# DISPOSITION FORM

SUBJECT Appl by S&WB to N.O. to dredge to -10.5 NGVD depth, relocate existing levee and floodwall, and install floodwall and fill to add two 1,000 cfs pumps to increase capacity to 10,400 cfs near Metairie

RE: LMNOD-SP(17th Street Canal)3  
Drainage Pumping Station No.6  
Sewerage and Water Board of  
New Orleans  
B&A Job No. 8133-2

SLIP JOINT  
SECTION **B**  
Scale: 1"=1'-0"

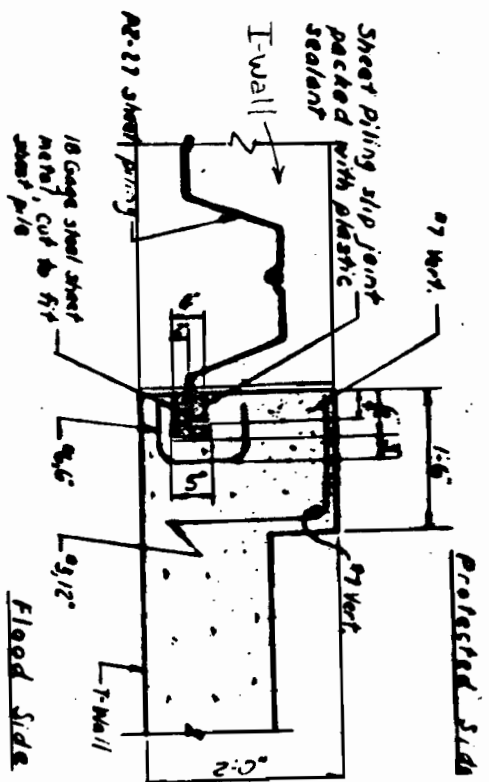
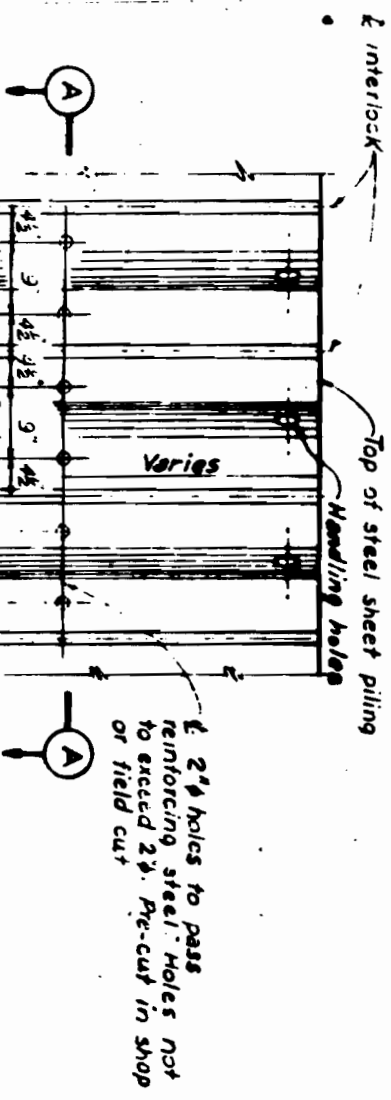
i. No details have been presented for monolith joints in the type "C" I-wall. A monolith joint should be provided at a sheet pile interlock, with 3-bulb waterstop, approximately every 30 feet. A transition slip joint should be provided at a sheet pile interlock where the soil supported I-wall ties into the floodwall over the pile supported discharge culverts. This will allow for differential settlement between the culverts and the type "C" wall. (See inclosure 2).

ELEVATION

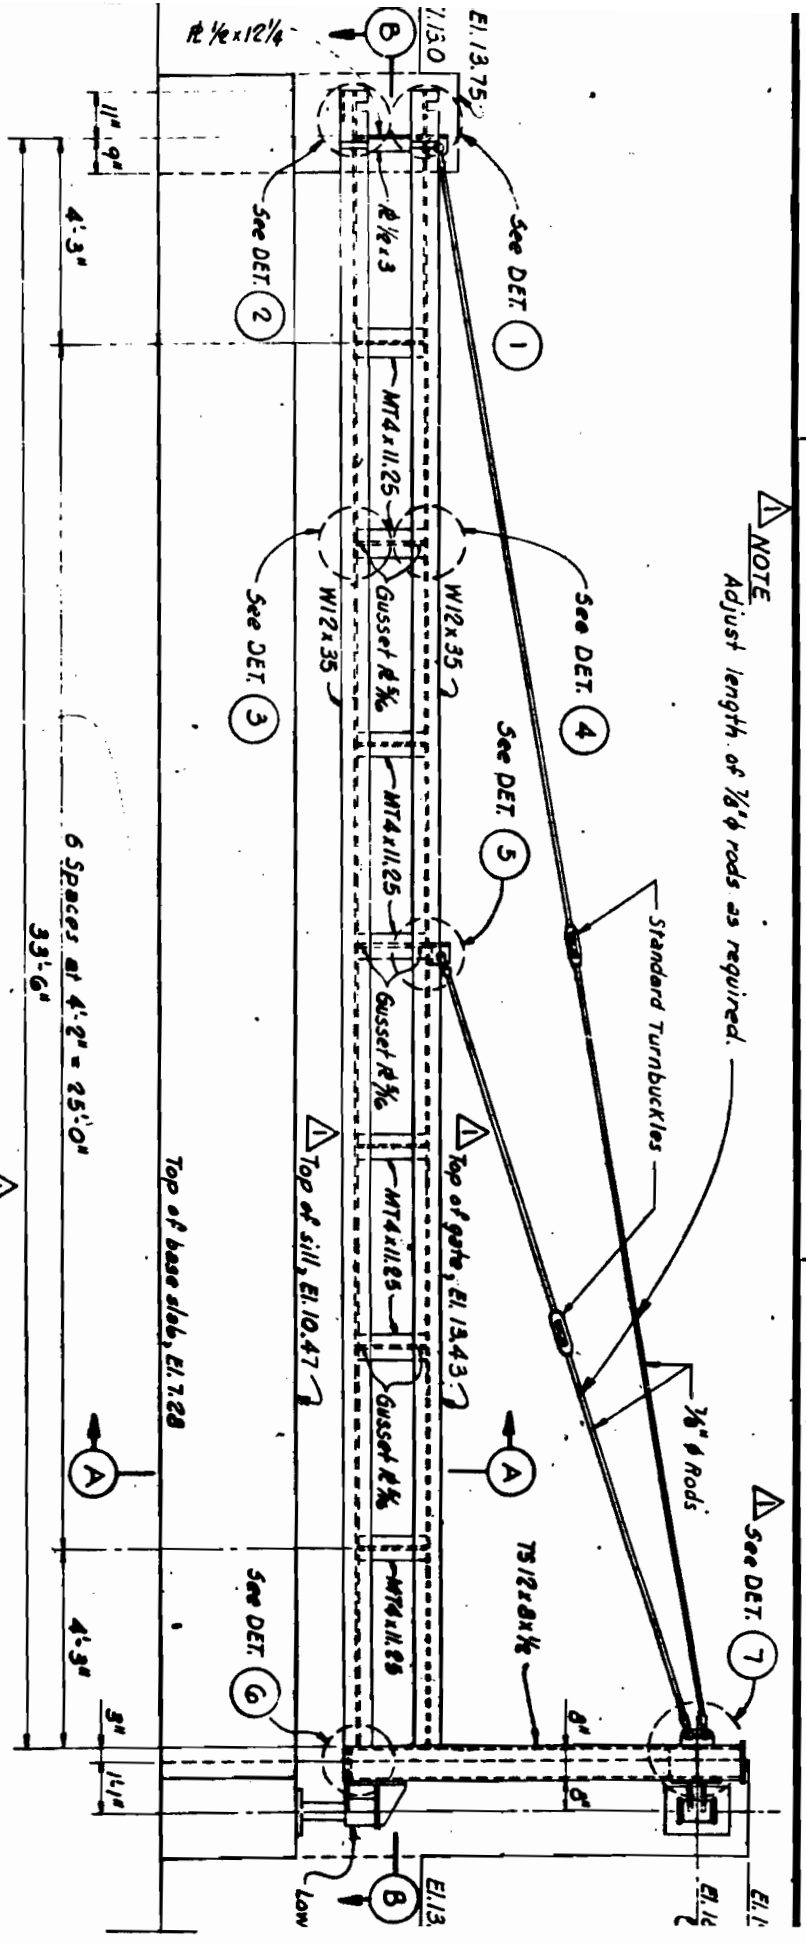
j. Design computations for the steel portion of the railroad swing gate should be presented for our review. It is recommended that the support tie rods should extend from the hinge column to the top of the gate as shown on inclosure 3. This helps distribute the gate weight more evenly to the hinges and prevent sagging of the gate.
